## PRODUCT CHANGE NOTICE

**PCN#26-004**

TC1.5-1+

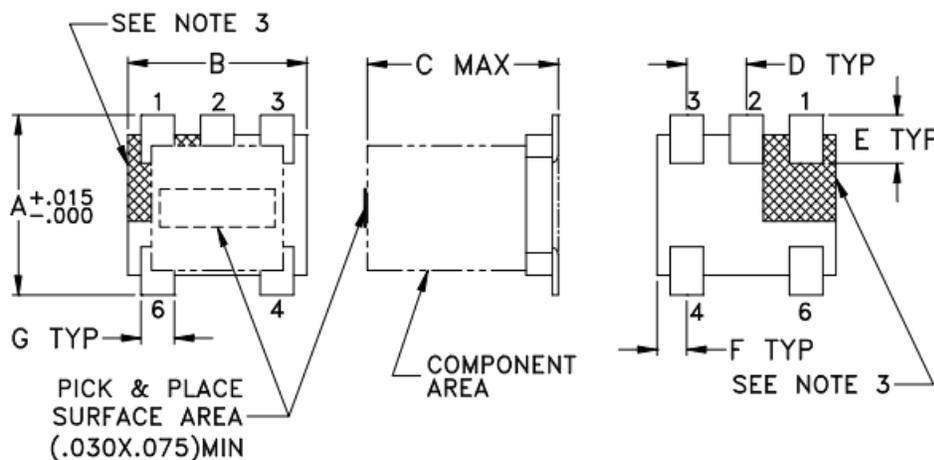
Change to FORM (appearance)

White mark, on core used as internal feature for manufacturing, may or may not appear in the final product. Device is not symmetrical.

Note 3. #1 identifier shall be located in the cross-hatched area shown. Identifier may be either a molded or marked feature.
